Staff Report to the Zoning Administrator

Application Number: **07-0150**

Project Description: Proposal to construct a two-story single-family dwelling of about 2,700 square feet (with a basement) which requires a Variance to reduce the front yard setbacks from 20 to 15 feet for a double frontage lot and Riparian Exception to reduce the setback from Schwan Lake from 100 feet to approximately 94 feet, and construct a decomposed granite driveway for access to an existing sanitary sewer.

SANTA CRUZ COUNTY SANITATION DISTRICT
SEWER VARIANCE FOR APN 027-082-12

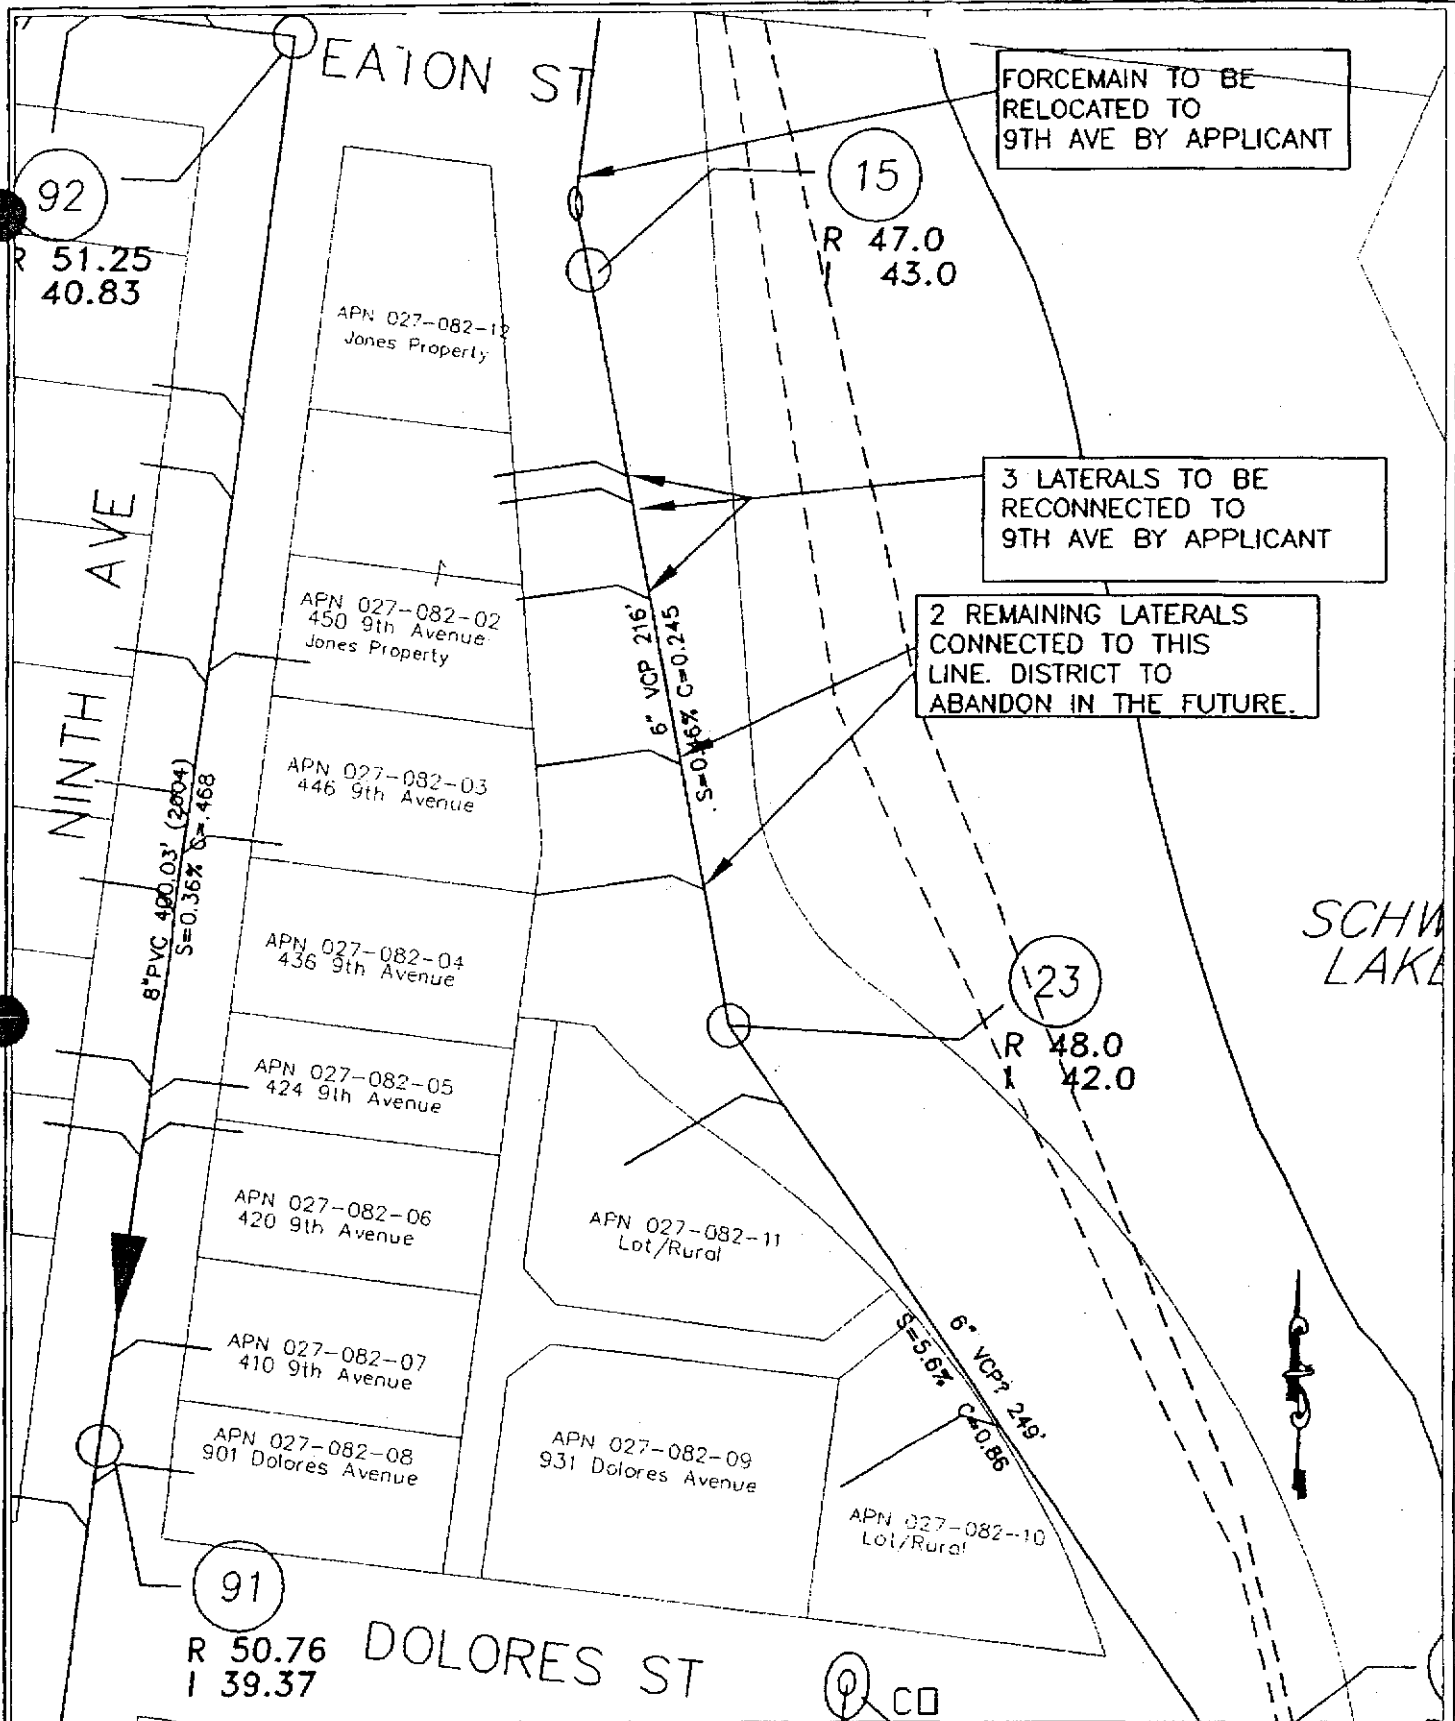
An older, vitrified clay sanitary main and a manhole are located between the proposed dwelling and Schwan Lake. The Department of Public Works, Sanitation is requiring the project to upgrade the vehicular access to this sewer line which needs infrequent maintenance. Although the Department of Public Works intends to eventually abandon this sewer line, there is no timeline established for this to occur. Incremental efforts to abandon the sewer line, however, have begun. On August 16, 2007, the Board of Supervisors approved a proposal in which the property owner will reconnect the sewer lateral on the subject property (and the lateral on an adjacent property which they own) to the new sewer main located in Ninth Avenue and provide a 12-foot wide driveway to the manhole (see Board Letter dated August 16, 2007: Exhibit H).
